The Village at Banfield Woods **Executive Summary of Submittal**

We are pleased to present you with a proposal for an Open Space Planned Unit Development (OSPUD) of 22 single-family dwelling units to be served by a private road which will be built to town standards.

R-TANKS - PROFILE VIEW
NOT TO SCALE

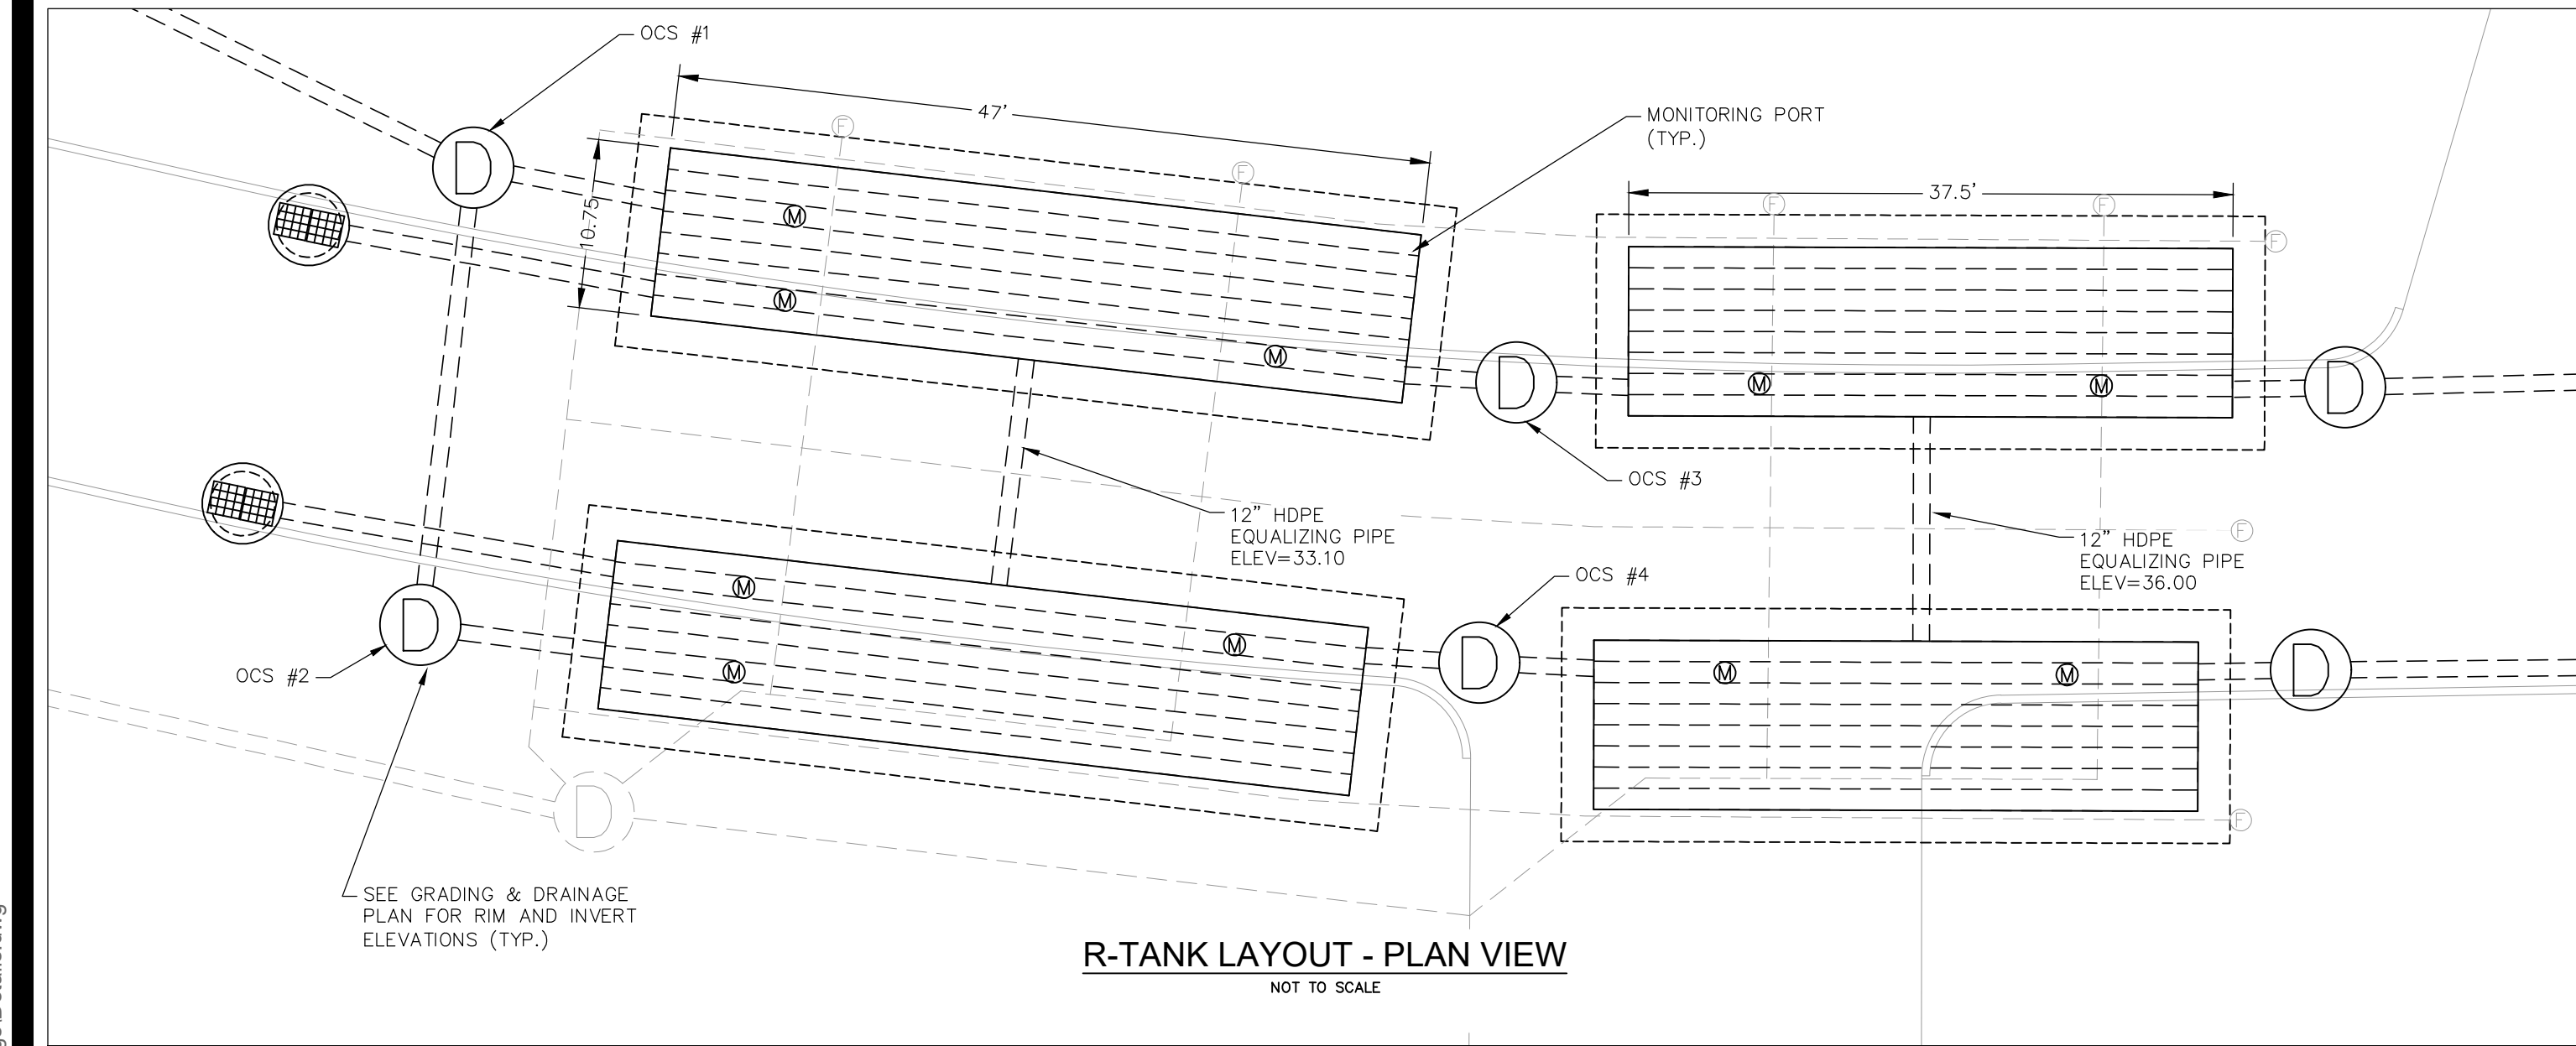
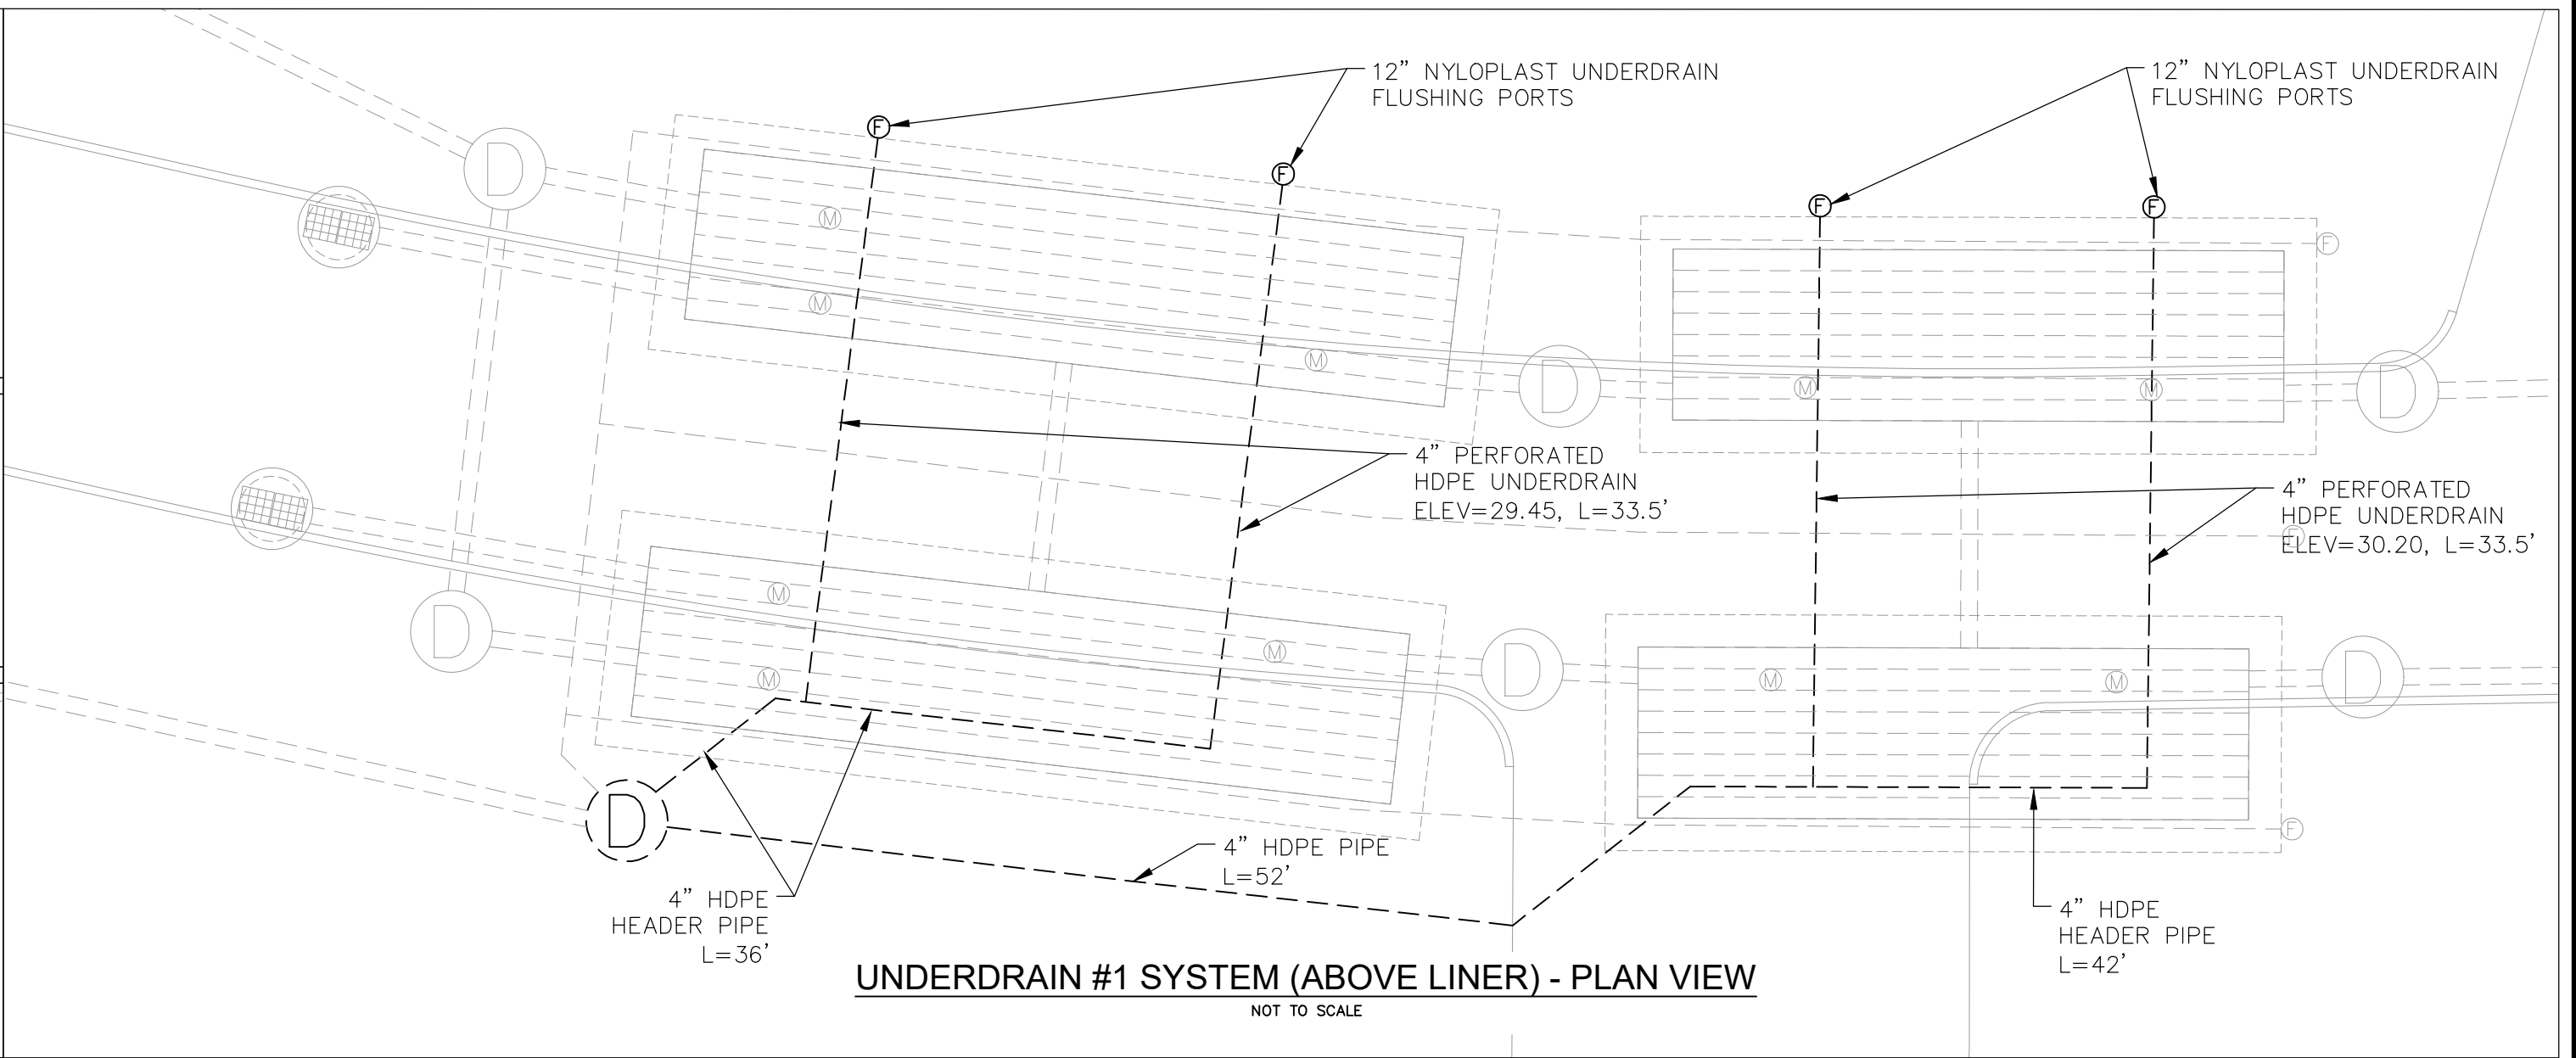
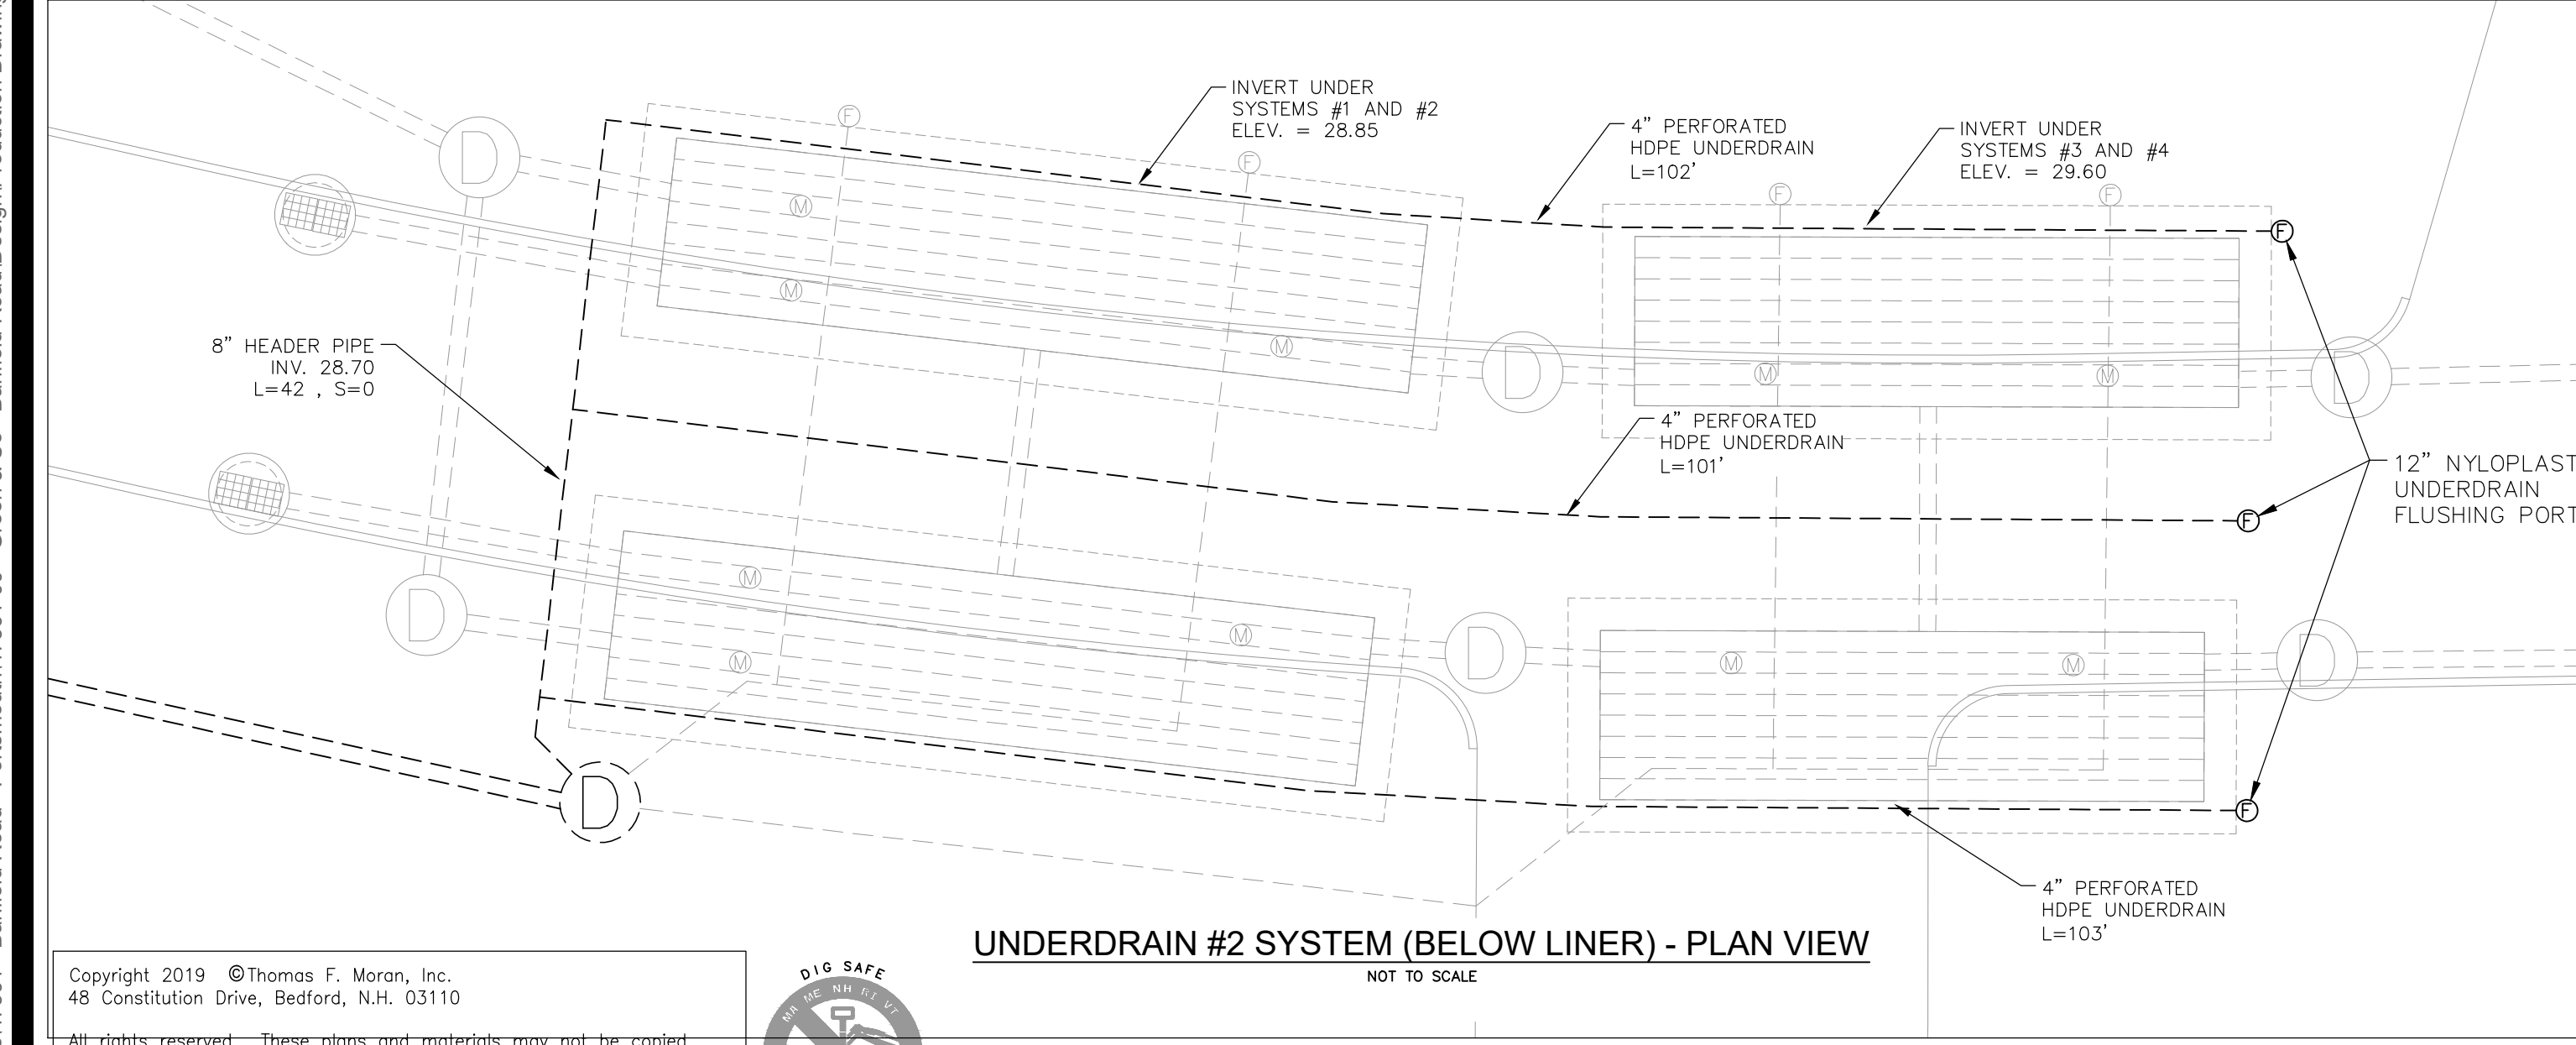
The R-Tank SD used in this application for HS-20 loads require a minimum of 18” of cover and a maximum of 108” to maintain a maximum load bearing capacity 42.9 PSI with a factor of safety ranging from 2.1 to 3.75 respectively. Sheet C-35 appears to detail more than sufficient cover to maintain load bearing capacity.

- Filter course specifications needed.** *Sheet C-35 lists a filter layer at the base of the R-Tanks. I do not see a specification for the filter layer for the subsurface detention and filtration.*
Revision: The filter course is an ASTM C33 sand with less than 2% passing the #200 sieve and is in accord with other designs I have worked with in the past.

- Maintenance ports.** *Sheet C-35 provides a detail for a maintenance port however the locations and number of ports are not detailed in the long-section or on the grading and drainage sheet C-10.*
Revision: The locations and number of ports are now detailed in the long-section on C-39 and on the grading and drainage sheet C-10. There are 2 maintenance ports shown on each R-Tank system with the specific location identified. This allows for proper monitoring of the system.
